<b>Flight Procedure Tracking Form</b>		<b>Action:</b> FLIGHT CHECK	<b>Task Type:</b> IAP	<b>Date Open:</b> 06/28/2016	<b>Task #:</b> 2014052728424305006	<b>Request #:</b> 20140527284243
<b>Procedure:</b> NDB RWY 13 ORIG			<b>Airport ID:</b> PADU	<b>Airport:</b> UNALASKA		<b>Reimbursable #:</b> NO
<b>City:</b> UNALASKA	<b>ST:</b> AK	<b>GPS #:</b>	<b>Estimated Chart Date:</b> 01/05/2017		<b>FICO #:</b> 1173617	
<b>Fac ID:</b> DUT		<b>Fac. Type:</b> NDB			<b>Specialist:</b> COLTON CROWDER	
<b>Procedure Review</b>						
	<b>Rec'd</b>	<b>Rel'd</b>	<b>Full Name</b>	<b>Comments</b>		
<b>Lead:</b>	12/23/2015	11/03/2016	DAVID DANNER	QUALITY		
<b>QA:</b>	11/03/2016	09/19/2016	DONALD LANIER	4 11/4CTabaka		
<b>Liaison:</b>	09/19/2016	09/19/2016	MARY MCDONALD	CHECKED		
<b>Procedure Comments:</b>			<b>Remark Type:</b> INFORMATION			
<p>SPECIAL PROCEDURE 8260-1(S): 6 NOTE: MISSED APPROACH IS NOT CODEABLE - NO .ARI FILE AVAILABLE. PENDING DATA USED FOR AIRPORT. PENDING DATA USED FOR DUTCH HARBOR (DUT) NDB/DME.</p> <p>ASSIGNED MAGVAR PADU: OLD 14E - NEW 9E</p> <p>CONTACT DON LANIER OR LONNIE EVERHART: 405.954.8242/4576</p> <p>11/01/16: THIS IS AN UPDATED COPY OF THE FORM DEVELOPED ON 06/29/16</p> <

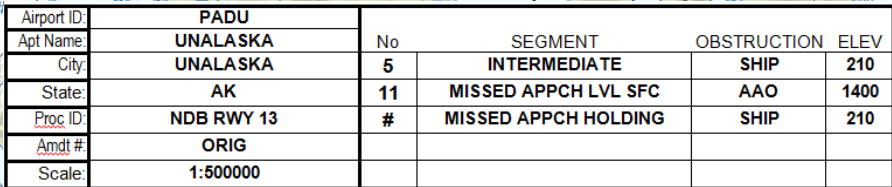
<b>FLIGHT INSPECTOR SIGNATURE:</b> kenneth e jack @ 10/10/2016 21:11			<b>PRINTED NAME:</b> JACK, KENNETH EARL			<b>NOTAM INITIATED?</b> <input type="checkbox"/> YES <input checked="" type="checkbox"/> NO
<b>FLIGHT INSPECTOR REMARKS:</b> KP-09-151-16 DUT PROC/A NDB RWY 13: Completed Sat with the following changes: Category D Minimums N/A due to flyability. Do not publish Cat D minima. Cat D maneuver speed to high for surrounding terrain.						
<b>IN-FLIGHT OBSTACLE REPORT</b>						
<b>OBSTRUCTION ID #:</b>	<b>COORDINATES OR LOCATION:</b>	<b>GNSS ALTITUDE (MSL):</b>	<b>BAROMETRIC ALTITUDE (MSL):</b>	<b>HEIGHT ABOVE GROUND LEVEL:</b>

**MISSED APPROACH:**  
Immediate climbing left turn to 2500  
on DUT NDB/DME brg-351 to  
WAKRA/DUT 14 DME and hold  
# Missed approach requires a minimum  
climb of 453 feet per NM to 2100.  
## Missed approach requires a minimum  
climb of 300 feet per NM to 2100.

Airport ID:	PADU				
Apt Name:	UNALASKA	No	SEGMENT	OBSTRUCTION	ELEV
City:	UNALASKA	1	FEEDER	AAO	2851
State:	AK	3	INITIAL	SHIP	210
Proc ID:	NDB RWY 13	8	PROCEDURE TURN ENTRY ZONE	AAO	2645
Amdt #:	ORIG	9	PRECEDURE TURN MANEUVERING AREA	SHIP	210
Scale:	1:500000

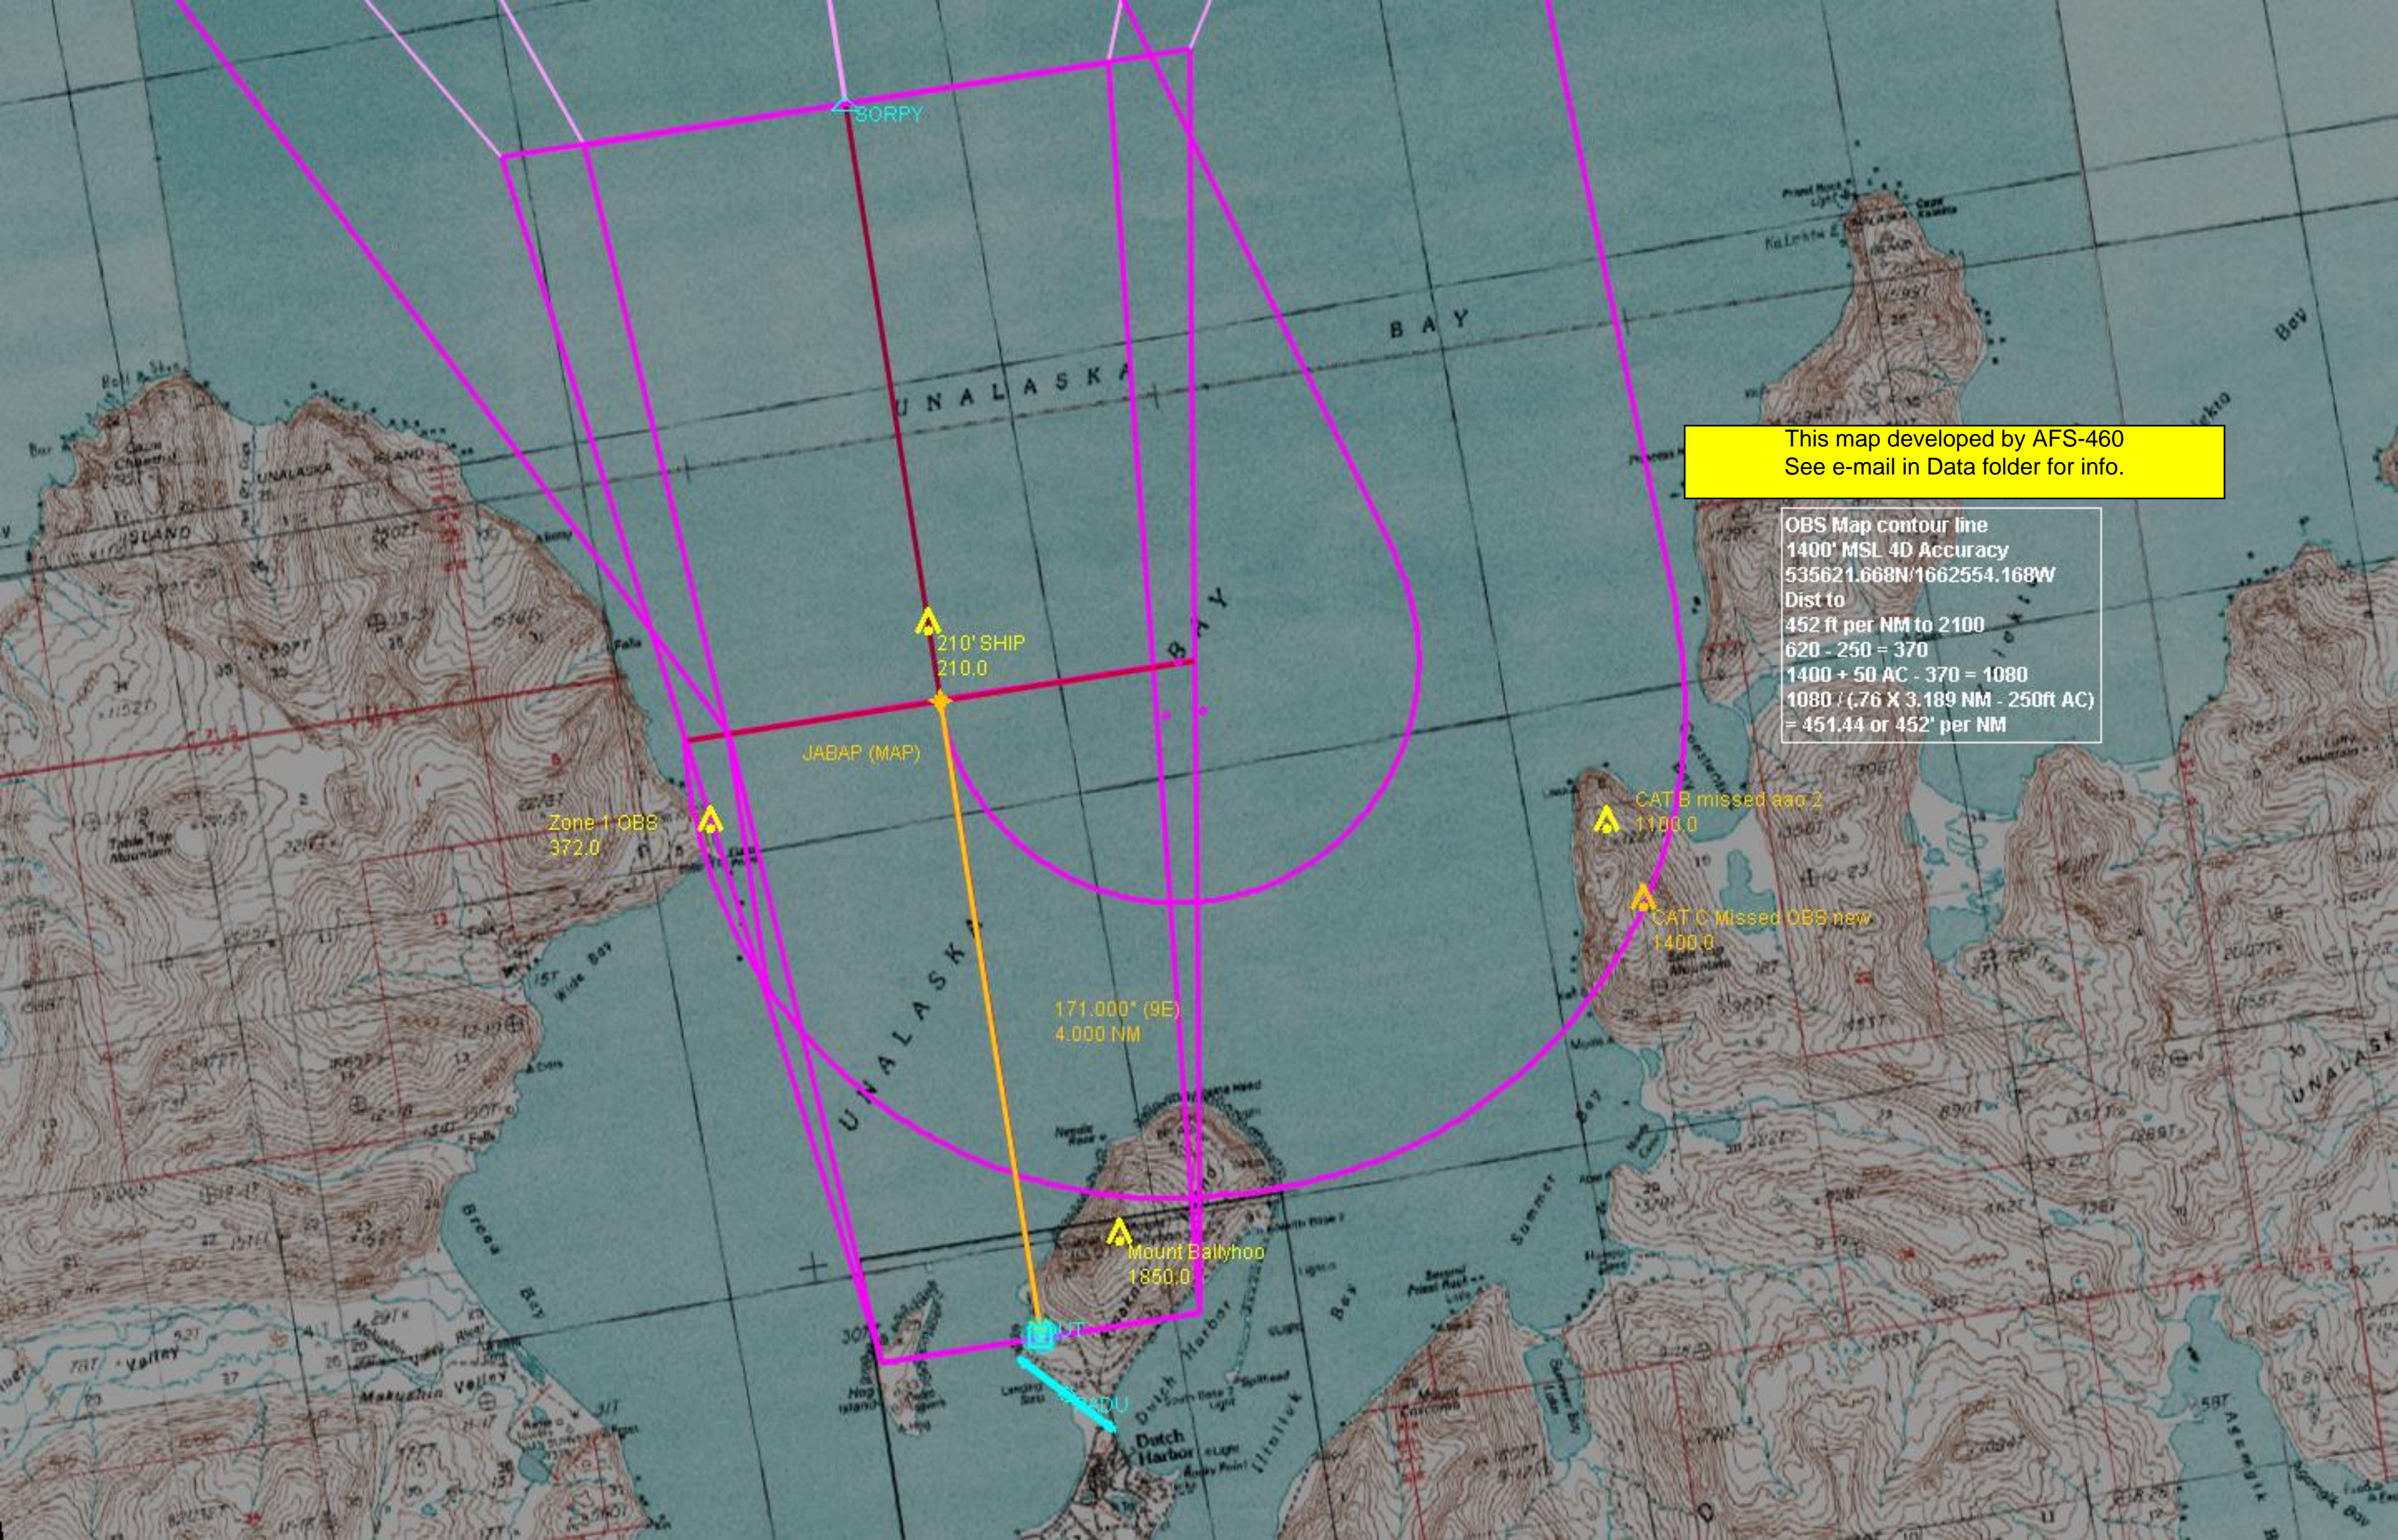
OBS Map contour line  
1400' MSL 4D Accuracy  
535621.668N/1662554.168W  
Dist to  
452 ft per NM to 2100  
 $620 - 250 = 370$   
 $1400 + 50 \text{ AC} - 370 = 1080$   
 $1080 / (.76 \times 3.189 \text{ NM} - 250 \text{ ft AC})$   
 $= 451.44 \text{ or } 452' \text{ per NM}$
